SERVICE	B0303025
BULLETIN	2003-11

Subject: Clutch Replacement Broad Area Mower PN 539106329

Models Affected: 968999214,BZ6134D 968999216,BZ7234D, 968999218, BZ6127D

Figure 9

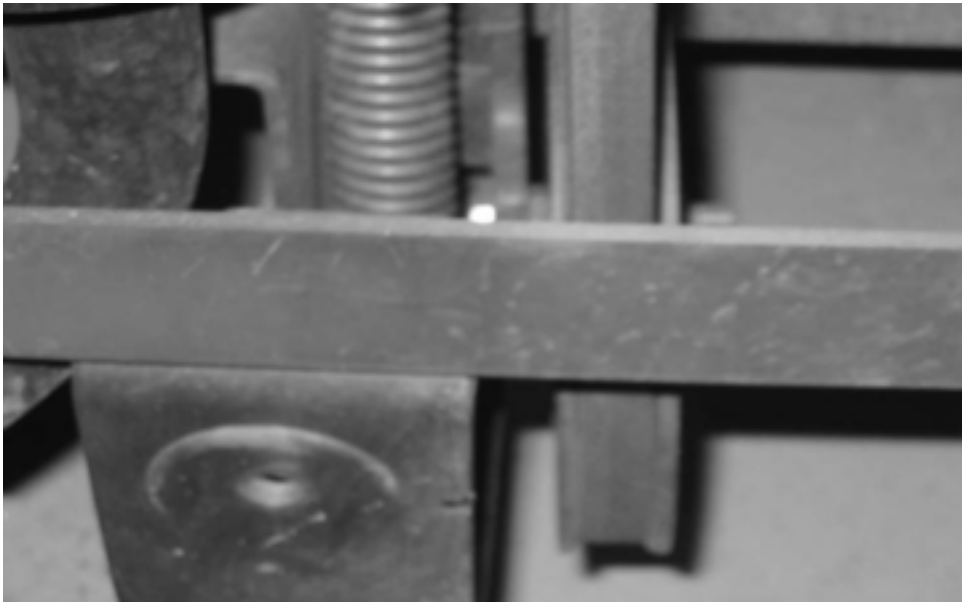
14. Raise the left side idler (figure 9) with a 2x4 or similar lever to raise the idler and release tension on the mule belt. With tension removed, you can reposition the fixed idler loosened in step 7. Using the mark you made try to reposition to its previous location. It will be close to level with the opposite side pulley when the finished.
